NUMBER: 84-9

FUEL PUMP IMPROVEMENT MARINER 20 (U.S. BUILT) MERC 18XD & 25XD

FUEL PUMP IMPROVEMENT INSTRUCTIONS

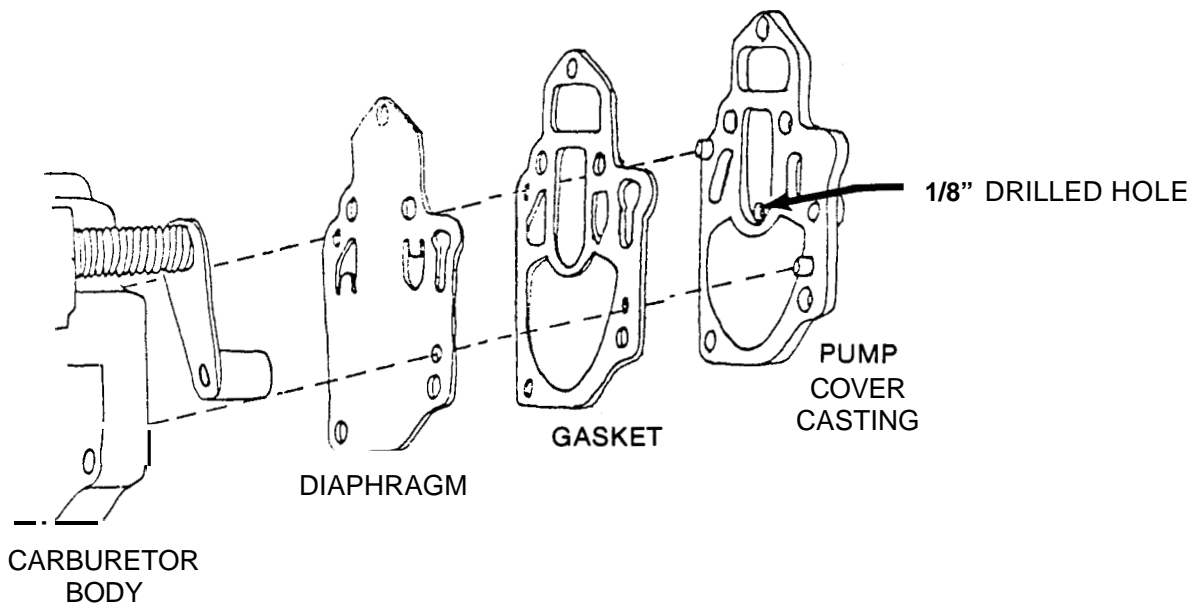
1. Disassemble fuel pump plate from carburetor, discard gasket and black diaphragm.
2. Drill $1/8"$ (.125) hole thru fuel pump cover plate as shown.

THIS VENTS THE BACK OF A PULSE CHAMBER

3. Reassemble with new gasket, and new **thicker** pump diaphragm. The new diaphragm has a greater resistance to falling into the check valve holes.
